**RFI Response - 20 January 2022  
757-763 George Street, Haymarket**

**RE: RESPONSE TO REQUEST FOR FURTHER INFORMATION – 757 – 763 GEORGE STREET,  
HAYMARKET**

# 757-763 George Street

Response to RFI  
20 January—2022

**Figure 1** – Wind testing locations and compliance with wind comfort and safety criteria

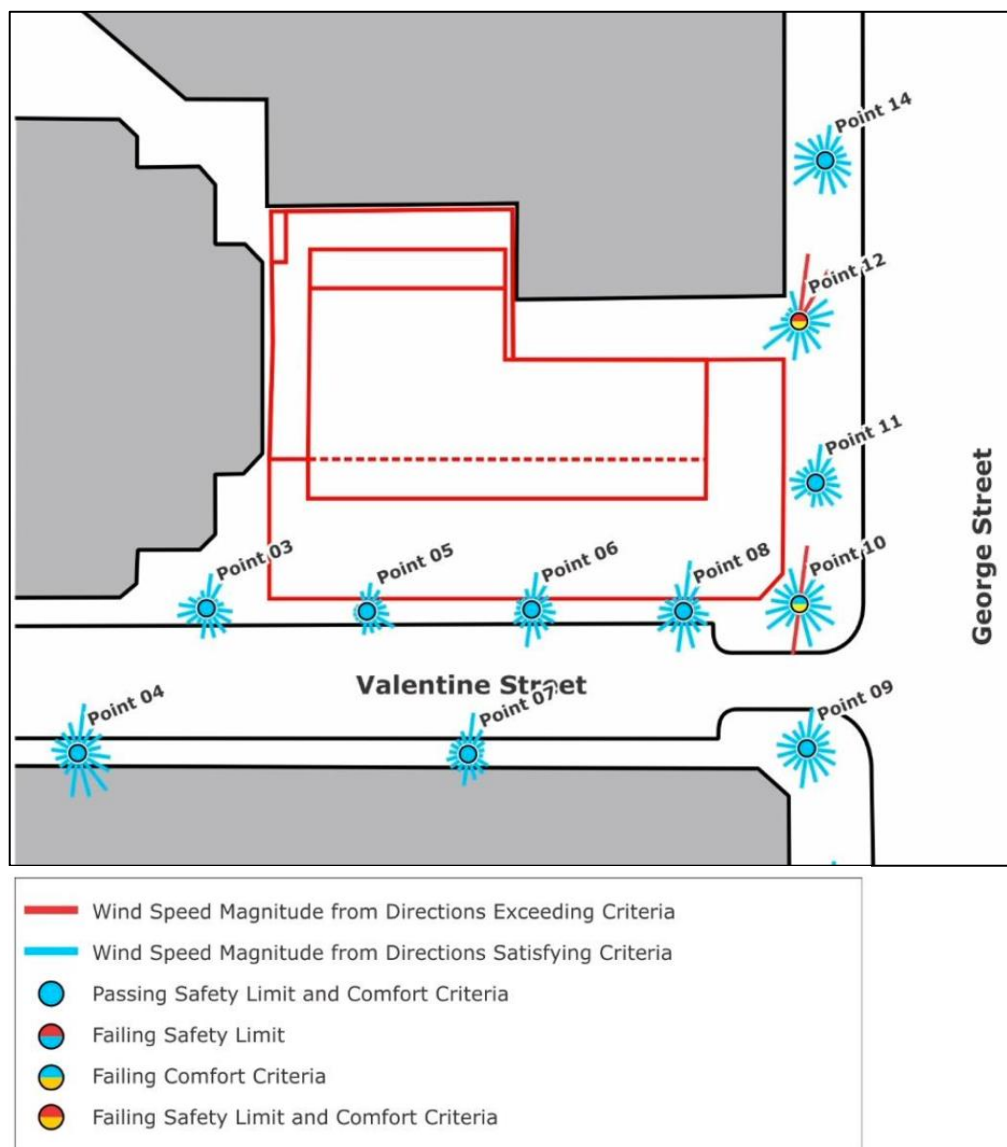
Council identified that two testing locations fail to meet the wind comfort rating and exceed the wind safety standard. These testing point locations consist of **Point 10** and **Point 12** which are identified in **Figure 1** below.

The wind testing results conclude that Points 10 and 12, as shown in **Figure 1** below, exceed the relevant criteria thereby resulting in a minor non-compliance with Section 5.1.9. Specifically:

- Point 10 provides a minor exceedance to the wind speed comfort criteria; and
- Point 12 provides a minor exceedance to the wind speed and safety criteria.

- Windtech have undertaken further wind testing (**Appendix 2**) to assess whether the proposal is capable of complying with Section 5.1.9. The results confirm that the proposal, and specifically Points 10 and 12, is capable of achieving full compliance with the applicable wind provisions subject to minor design changes and mitigation measures, including the existing heritage awning and a small building chamfer along the north-eastern corner of the podium. These are discussed further below.

- The updated wind testing consisted of a re-test of all 18 study points and accounted for the **existing awning associated with the heritage listed Sutton Forest Meat Building** at 757 – 759 George Street which is not proposed for removal and is expected to remain in perpetuity.

- The preferred envelope incorporated the wind mitigation design measures recommended by Windtech which included small **building chamfer** which is shown in green below in **Figure 1**. This area has already been removed in the indicative scheme and as such would not have an impact on the available FSR.

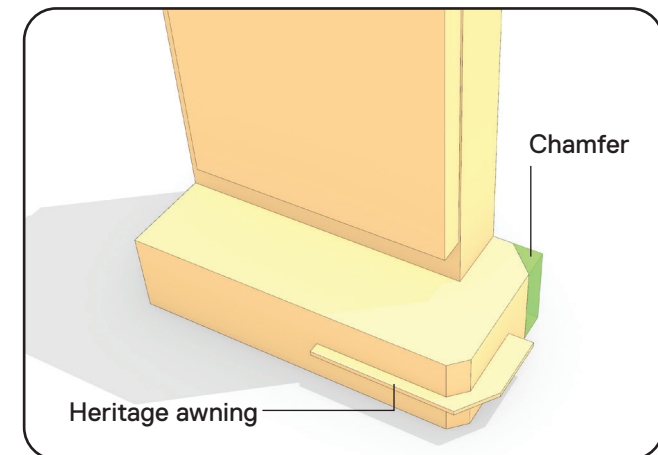
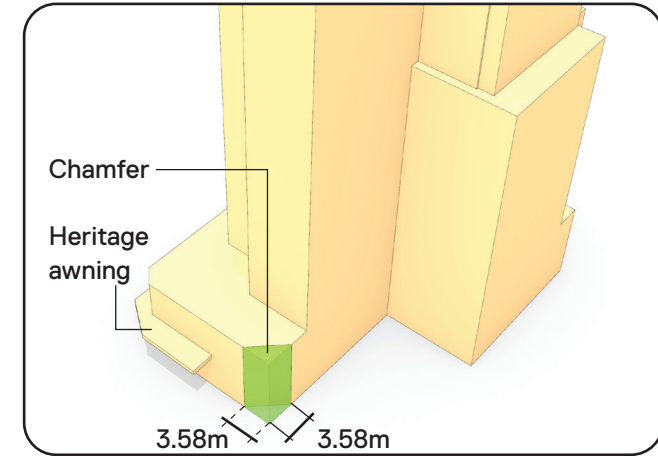
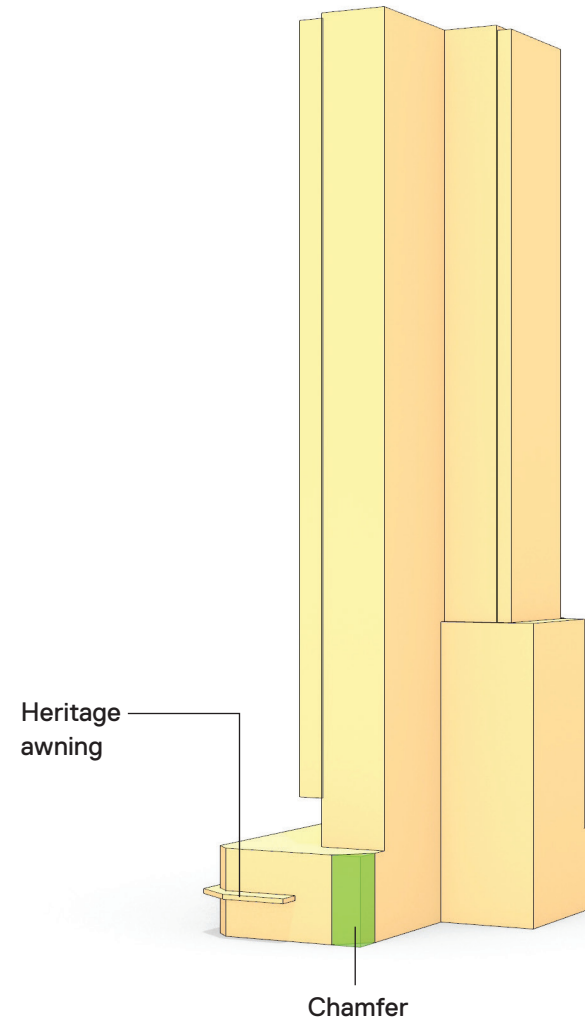
*Two locations with a wind comfort rating of 'uncomfortable' and an exceedance of the wind safety standard.*

*Additional wind testing to identify opportunities for wind mitigation, including amending the planning envelope's geometry to help calm these locations.*

As requested by Council we have undergone further wind tunnel testing to prove how the envelope can achieve compliance and eliminate the minor exceedences to Points 10 and 12.

Windtech's study proved that Point 10 will be pass with the inclusion of the heritage awning above.

For Point 12, a small chamfer at the podium level of 3.58m x 3.58m is enough to make the test point compliant. It is worth noting that this area has already been removed in the indicative scheme and as such would not have an impact on the available FSR.

# Proposed DCP Envelope

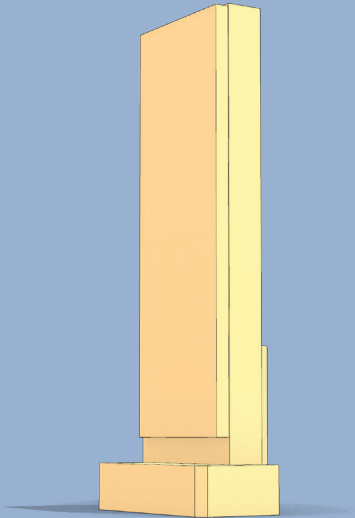
*The revised planning envelope is highly constrained and does not include sufficient flexibility to address environmental amenity issues... the planning envelope does not meet the architectural articulation quotient or include a suitable façade zone as required by the draft Central Sydney DCP.*

*The planning envelope should be further revised and resubmitted to the City for assessment. It is recommended this revised envelope include a lower GFA that would provide the flexibility to respond to the above issues and accommodate sufficient setbacks to the northern boundary that would protect the amenity of your hotel should the adjoining site redevelop in the future.*

The scheme incorporates an **articulation zone of 11% which includes a zone for shading devices and the like**. The proposed articulation zones do represent a non-compliance with Section 3.3 – Design Excellence and Competitive Design Processes dated February 2020.

As provided below and demonstrated in the Grimshaw design package, 11% articulation is considered acceptable for proposal given the characteristic of the site and design outcomes achievable. Enforcing any further articulation zone required would be unreasonable and would negatively impact the development, without any tangible benefit to the design. The proposed articulation is considered acceptable for the following reasons:

- The proposed 11% design articulation provides a reasonable zone for articulation within the future design excellence competitions, while protecting the minimally viable scheme and the objectives of the CSPS.
- Given the nature of the site and inherent constraints, the proposed envelope already includes inbuilt architectural articulation. This articulation is largely a result of the increased setbacks incorporated into the building through the Planning Proposal process. Specifically, the proposed DCP envelope, prior to the subtraction of the required architectural articulation, adopts the following:
  - Articulation and separation from heritage building

# Schedule 12 Comparison

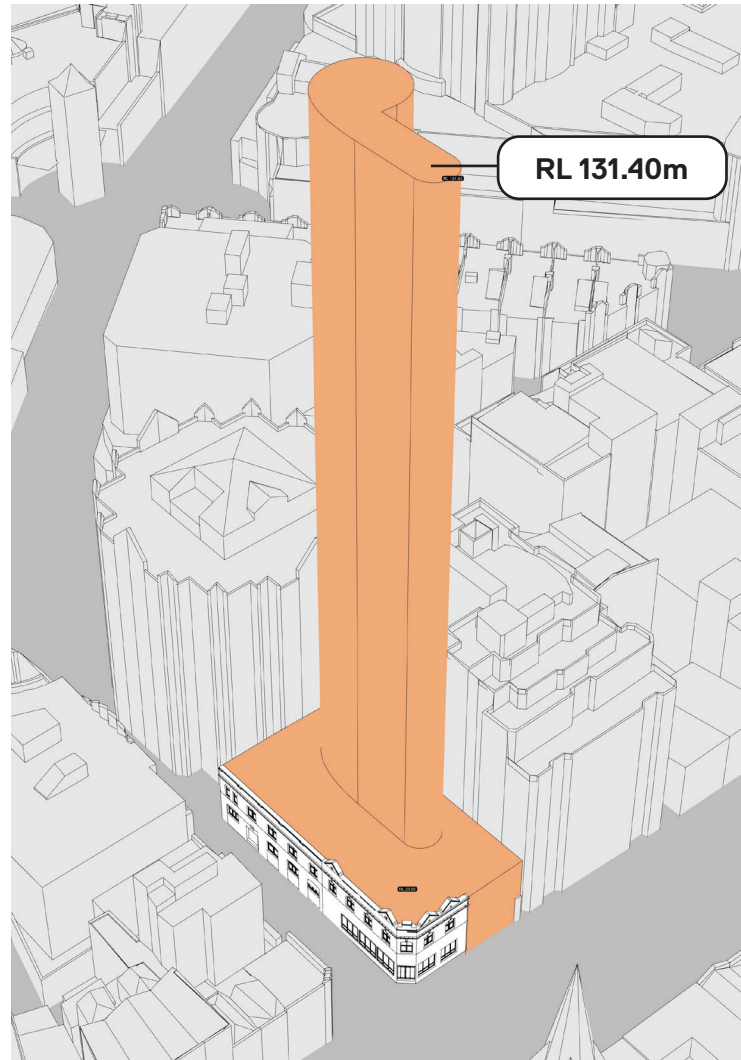
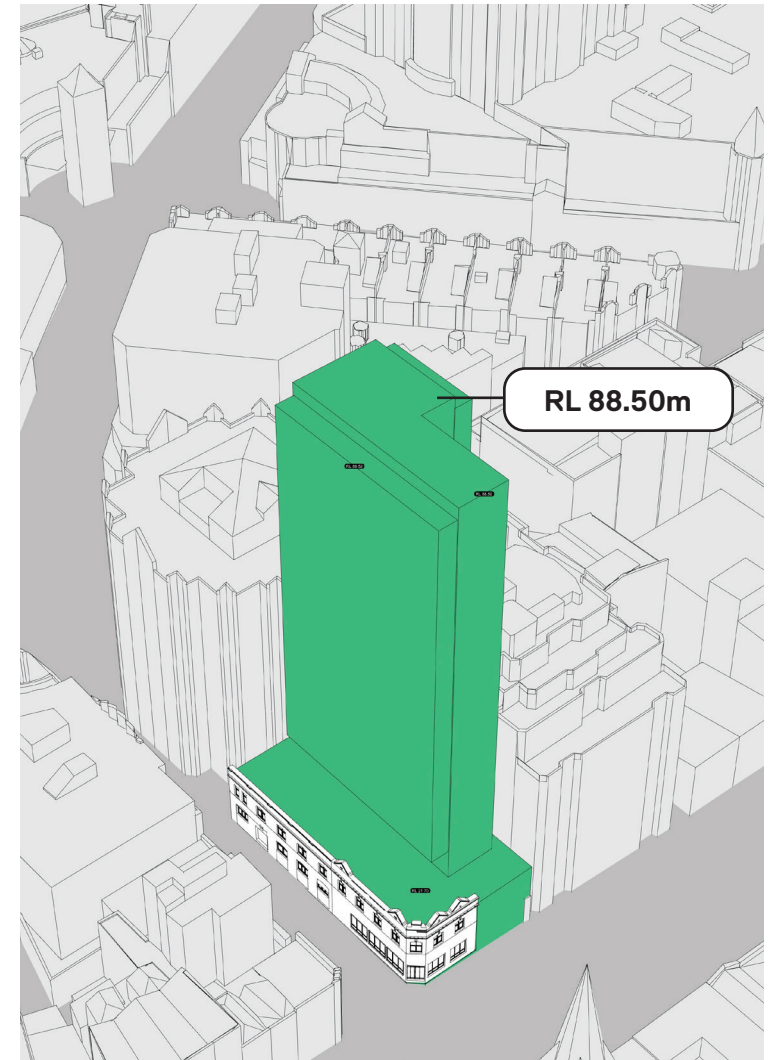
In accordance with Council's request, Grimshaw has undertaken a **comparative analysis** against the new Draft Guideline for Site Specific Planning Proposal's (Schedule 12) as provided in **Appendix 1**. As demonstrated in the analysis, the benefits to be achieved through the application of the articulation requirements under Schedule 12 would be nominal. Further, this would only serve to deliver an impracticable design and development outcome given the geometry and constraints of the site.

As requested by Council we undertook additional Schedule 12 analysis to compare the scheme against the current regulation.

For consistency the proposed envelope maintained the same setbacks as lodged October 2021.

While the updated regulation allows for an articulation zone of 8% inclusive of facade zone for buildings up to 120m, the requirement for filleting to all corners of the base case massing reduces the envelope significantly.
